Internal Review and Recommendations (IR&R) for NCWSA				
PWS Name:	Encina Fort Union LLC			
Summary description of the internal review and decision process:				
This NCWS application was submitted by Encina Fort Union LLC on May 4, 2023. The application was deemed administratively complete on May 17, 2023. An email listing technical deficiencies was sent on July 6, 2023. A response to the deficiencies was received on September 12, 2023. Although this is a NCWS, it was agreed that the technical services section would be responsible for the entire review.				
Add additional sheets if necessary				
	Print	Sign	Date	Approve/Deny
Sanitarian	N/A			
Sanitarian Supervisor	N/A			
Operations Chief	N/A			
Technical Services Section review (if necessary)				
Explain how new sources meet guidance (or justified alternative to guidance), including new source location and setbacks, well construction, pump testing, new source sampling, and surface water influence evaluation. Write "N/A" if Technical Services review is unnecessary.

Well Construction:

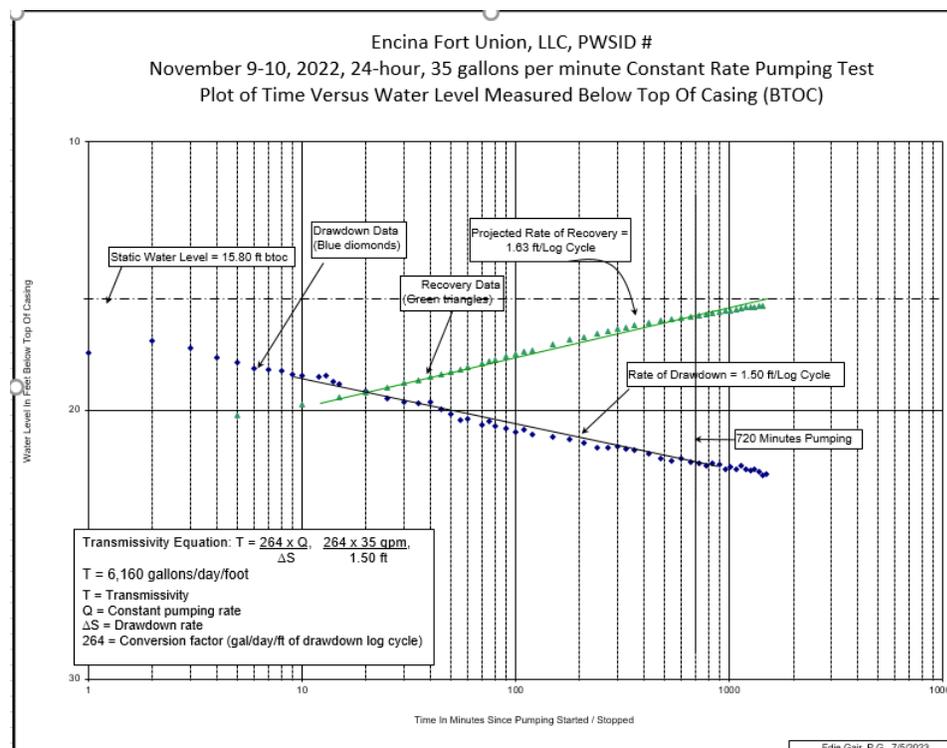
A 10-inch outside-diameter (OD) borehole was drilled through 8 feet (ft) of glacial outwash, consisting of sand, cobbles, silt, and clay. 11 ft of weathered shale, overlying gray limestone with interbeds of black shale and siltstone with some dolomite of the Keyser and Tonoloway Formations, undivided. A 6-inch inside-diameter (ID) steel casing, drive shoe, and centralizers were emplaced in the borehole to a depth of 108 ft below ground surface (ft bgs), and the annular space was tremie-grouted with a Portland cement/bentonite slurry. The borehole was drilled to a total depth of 365 ft bgs and intercepted a water-bearing zones at 115, 127, 134, 136.5, 147, 186, 193, and 255 ft bgs that produced a total blown yield of about 10 gpm.
